ASHA Consulting (Pty) Ltd

28 April 2021

HIGHLANDS SOUTH WEF, AMENDMENT APPLICATION: HERITAGE COMMENT DEFF REF NO.: 14/12/16/3/3/1/1960

Aerial view of the proposed Highlands South WEF showing the following:

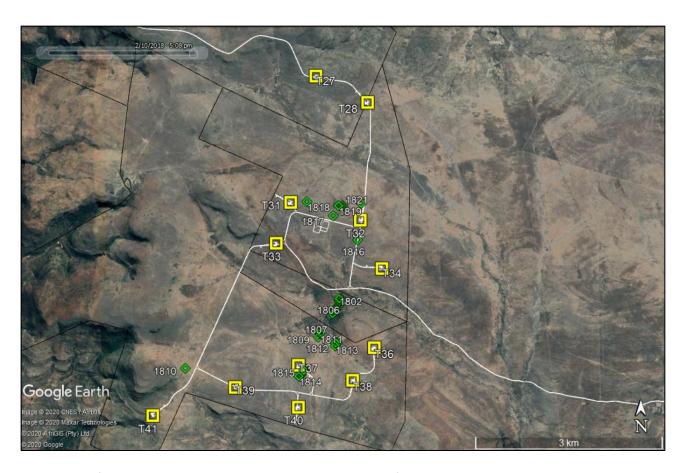
The proposed increase in size of these components could theoretically result in a higher likelihood of archaeological and palaeontological impacts occurring. However, it is noted that the original survey found very few significant sites and all of these have been avoided by the amended layout. Although a preconstruction survey is still required because the locations of archaeological and palaeontological sites is not fully predictable, the chances of impacts occurring are really little different to what they were before. All impact assessment ratings for both archaeology and palaeontology remain valid for the amended project. Note that potential impacts to graves were given the same significance ratings and these also remain the same for the amended project.

- Turbine locations yellow numbered squares
- Facility layout white lines
- Heritage resources (numbered green diamonds excluding fossils)

Aerial view of the area in which the substation, offices, laydown areas and BESS would be located.

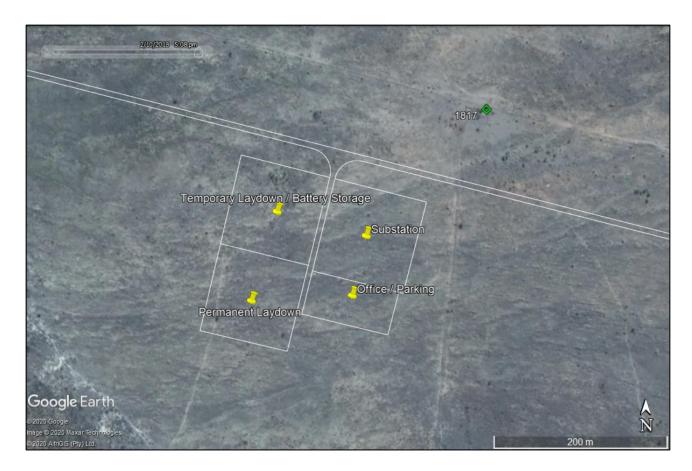
The addition of the BESS to the facility could result in further archaeological and palaeontological impacts as well as increased visual impacts. The significance of potential impacts to archaeology and palaeontology would not change, however, because the BESS is proposed to be located on the temporary laydown area. There would thus not be any new footprint to be disturbed. With regards to visual impacts, the BESS will be placed alongside the substation and operations/office area. This means that there would not be a new area with buildings. It is also relevant to note that the BESS would be located some 10.6 km away from that road and is unlikely to be openly visible. The significance ratings thus remain as noted above.

Aerial view of one of the two very low significance heritage finds that will be impacted. Waypoint 1816 is an isolated standing stone alongside a farm track. It may be an old fence post or a beacon of some sort.

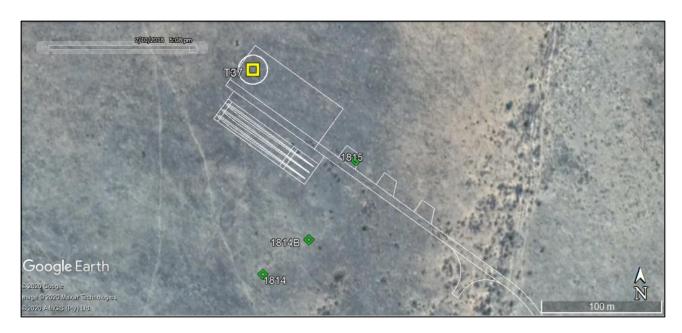
Aerial view of one of the two very low significance heritage finds that will be impacted. Waypoint 1815 is cluster of stones that may have once formed a small stone feature/structure.
